ADDENDUM NO. 2

Project: Hanover Road Sewer Meters
AWCK Project No. 22009

Addendum Date: March 16th, 2023

SANITARY SEWER
PLAN & PROFILE

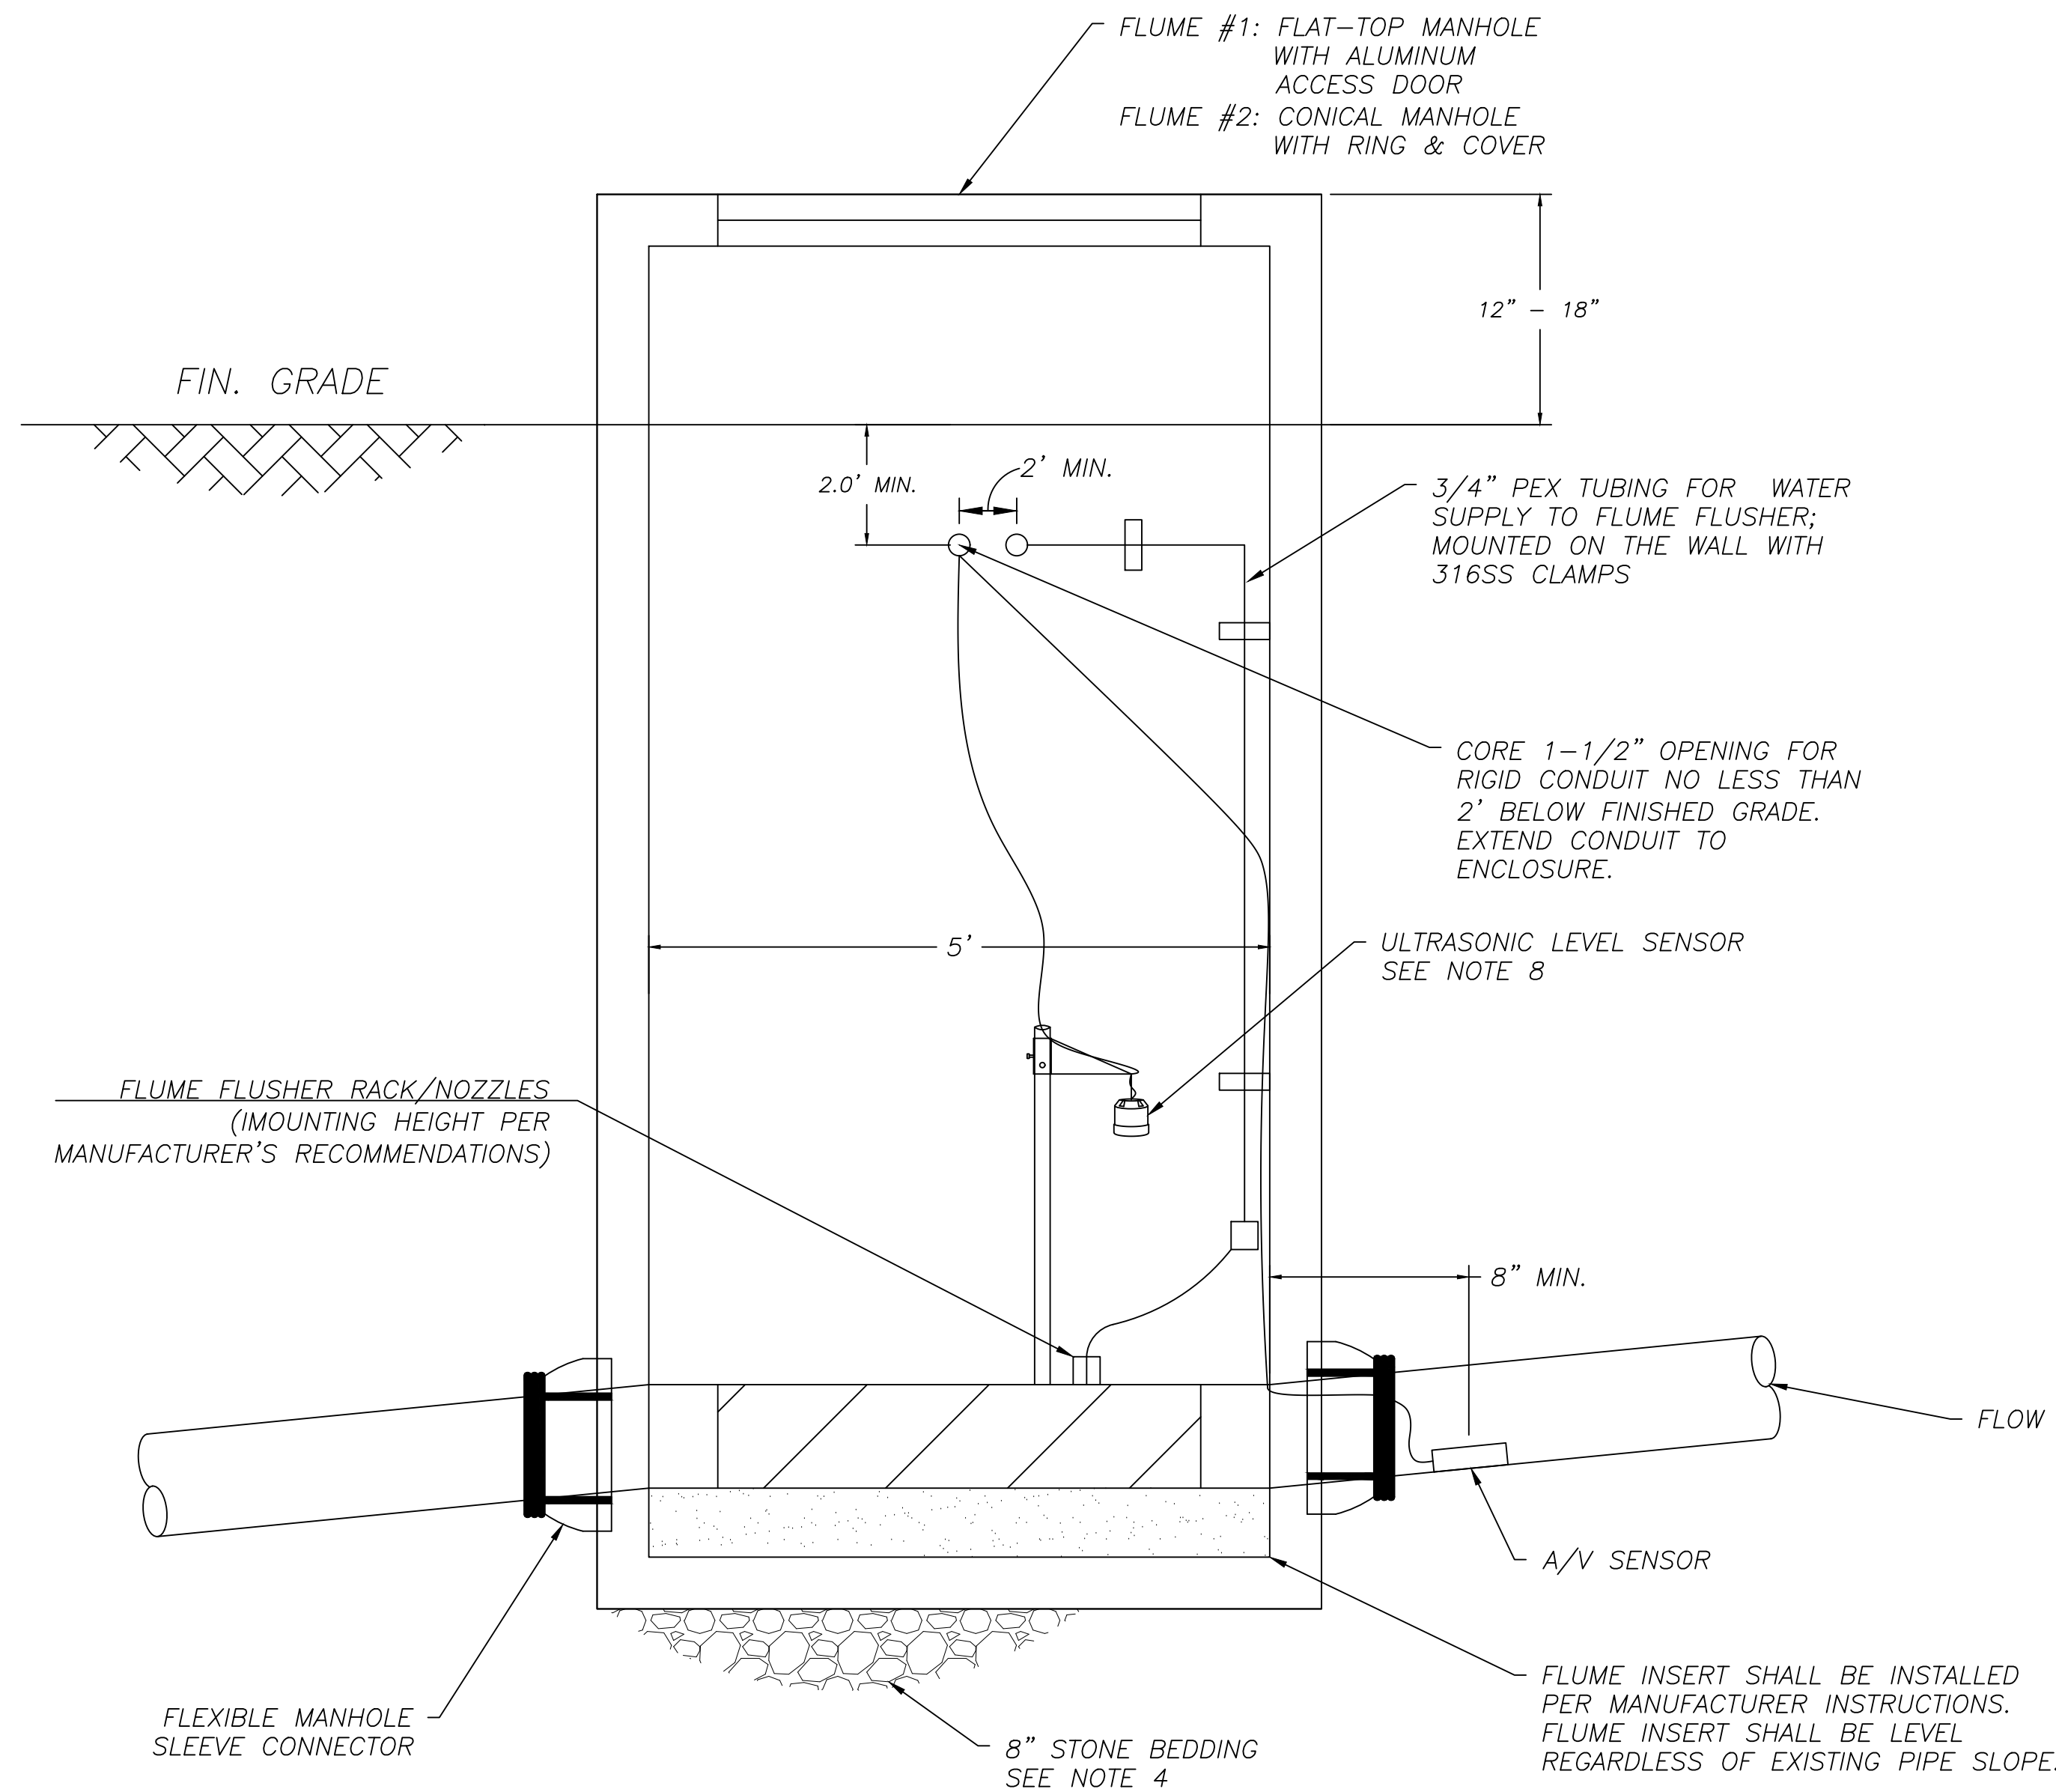
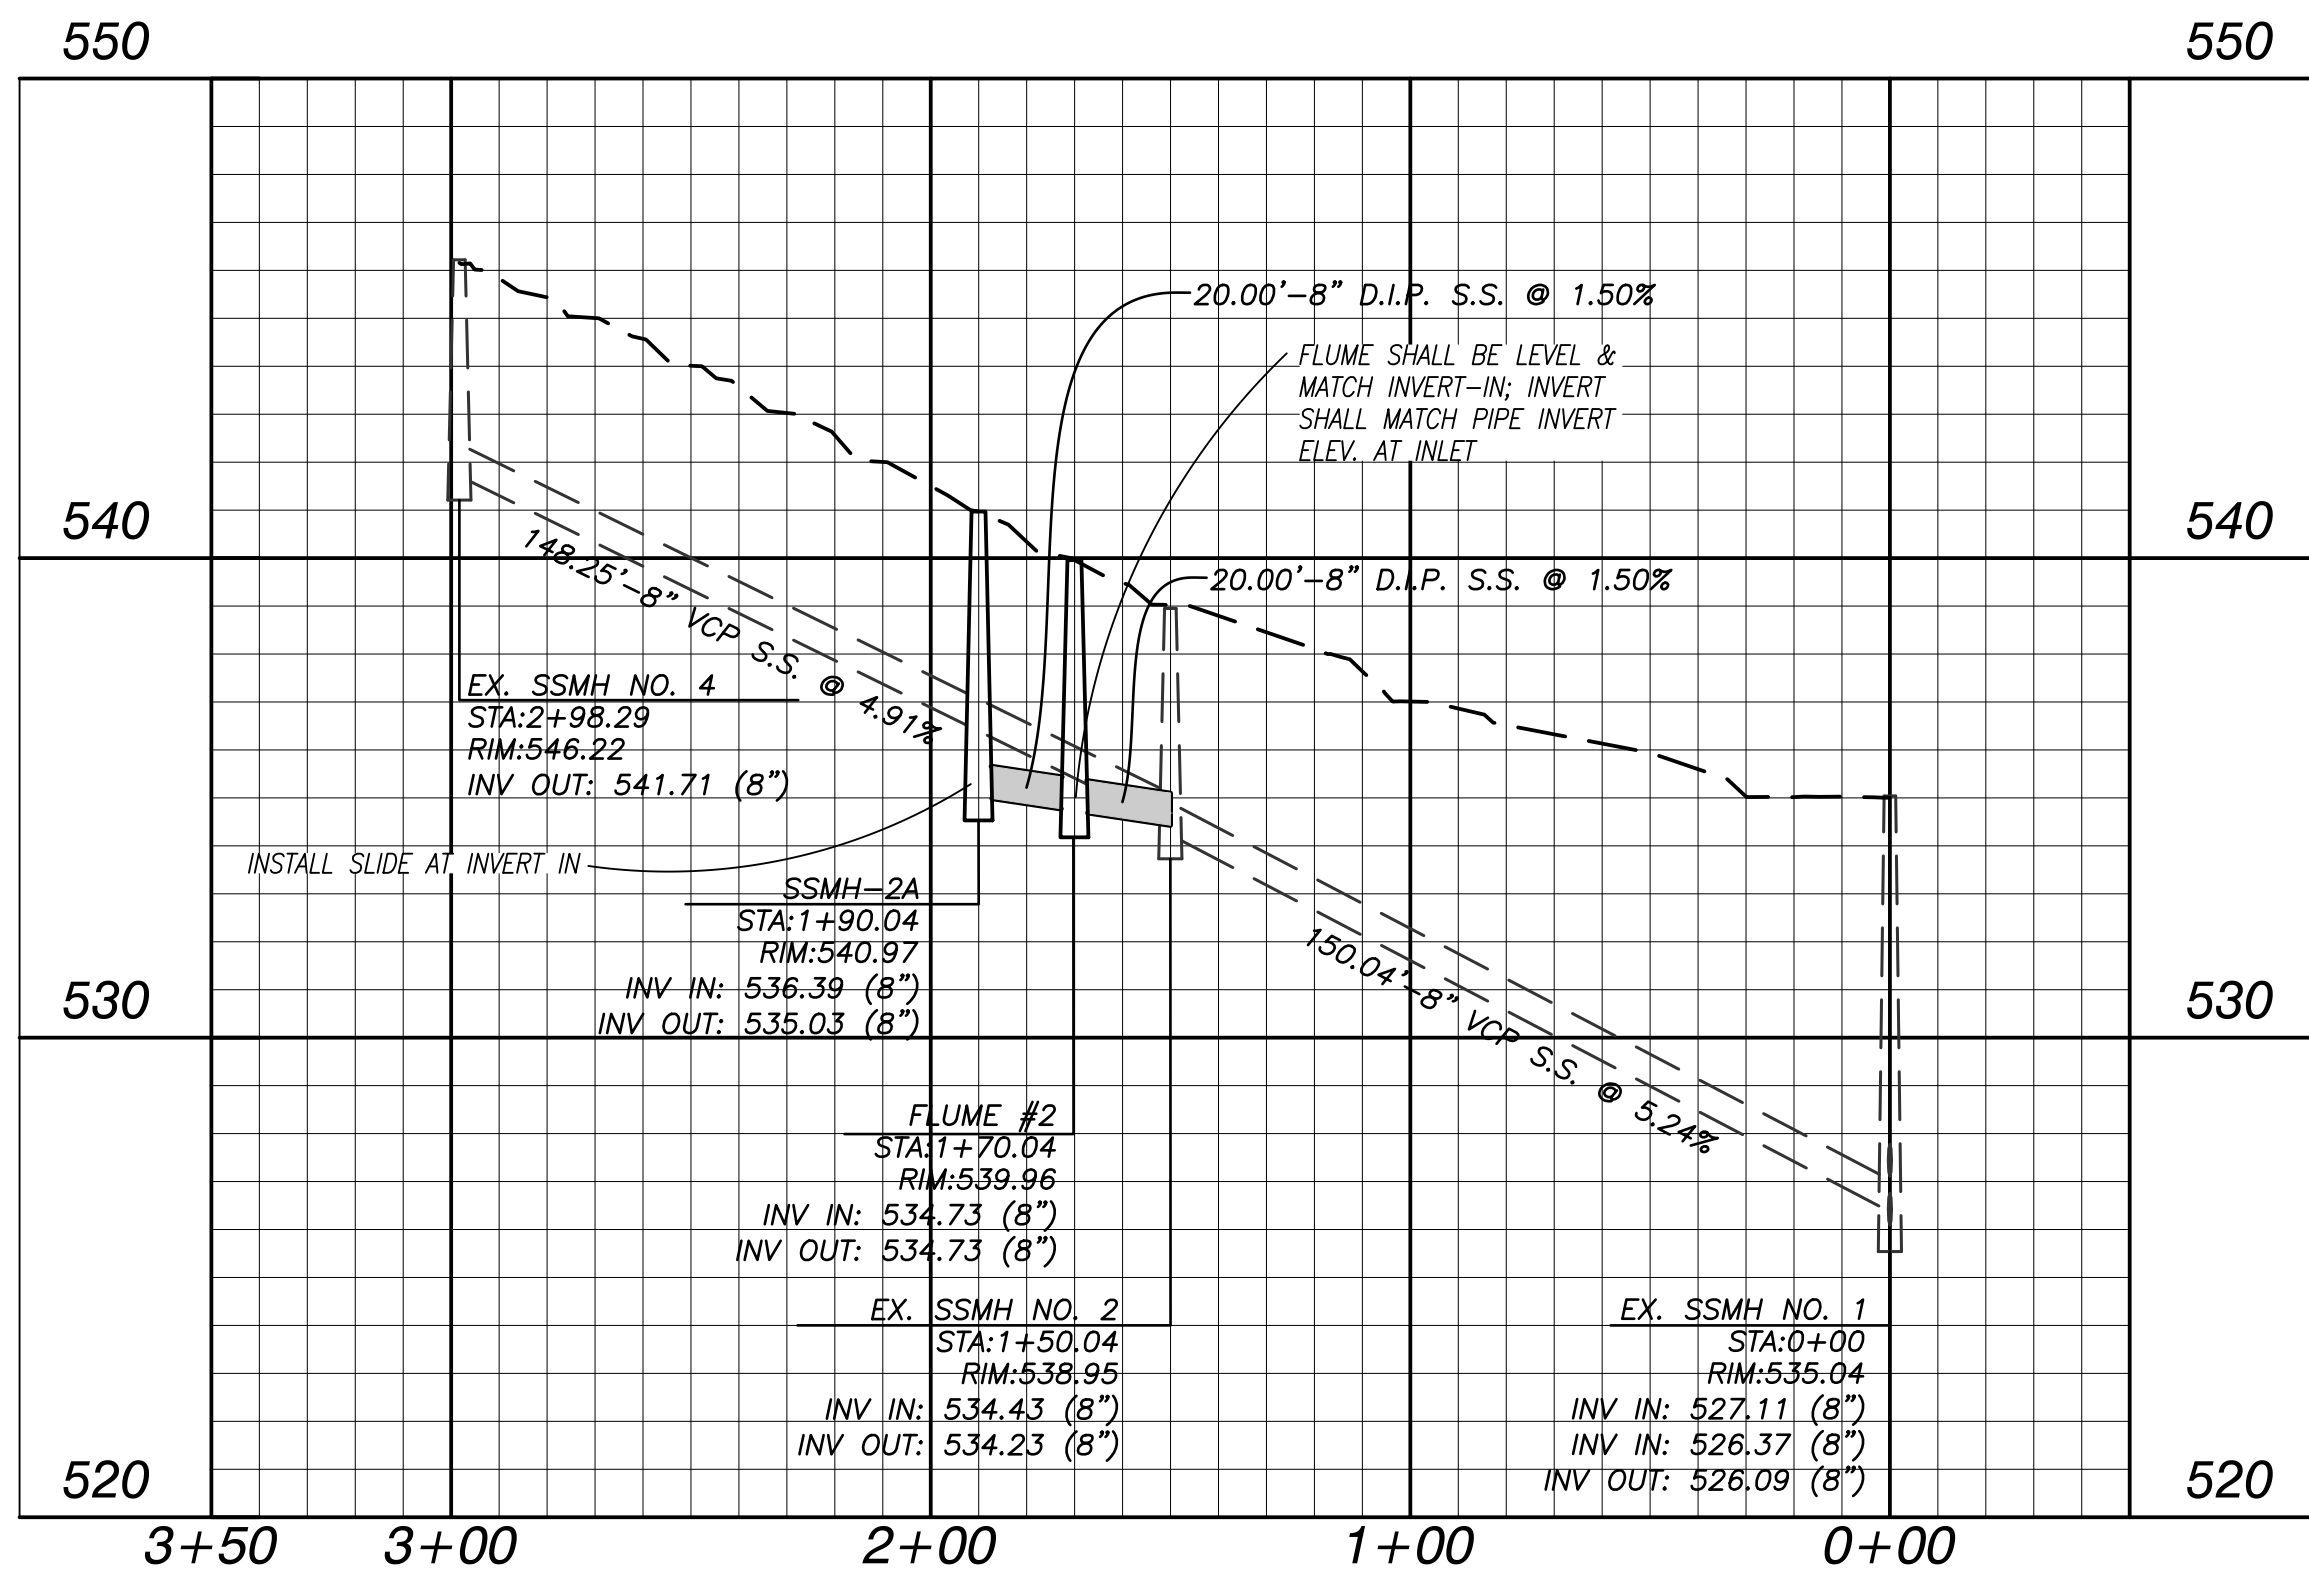
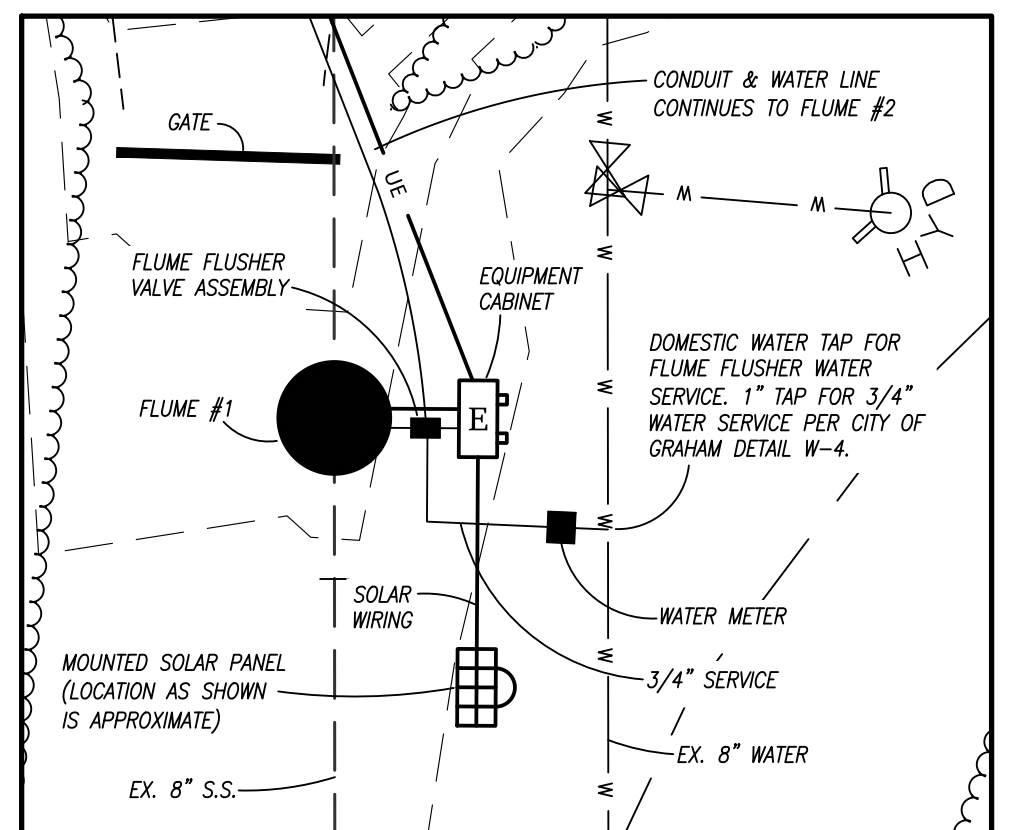
1. Plan Sheet 2 was revised to include an additional manhole (SSMH-2A) and ten additional feet of proposed 8" ductile iron sewer main. The slope of the proposed sewer main was reduced to 1.50% to increase meter accuracy. A slide will be installed within SSMH-2A to make up the elevation difference caused by the slope reduction. The limits of the pavement repair have been adjusted to accommodate the additional pipe length and manhole SSMH-2A. General notes on Plan Sheet 2 have been revised to accommodate the addition of SSMH-2A. Costs associated with these revisions shall be included within the lump sum bid item for Flume #2 (Bid item #4).
2. Note 14 was added to Plan Sheet 3 to provide additional information regarding the solar equipment to be provided by the contractor. Costs associated with this solar equipment shall be included within the lump sum bid item for Flume #1 (Bid item #3).
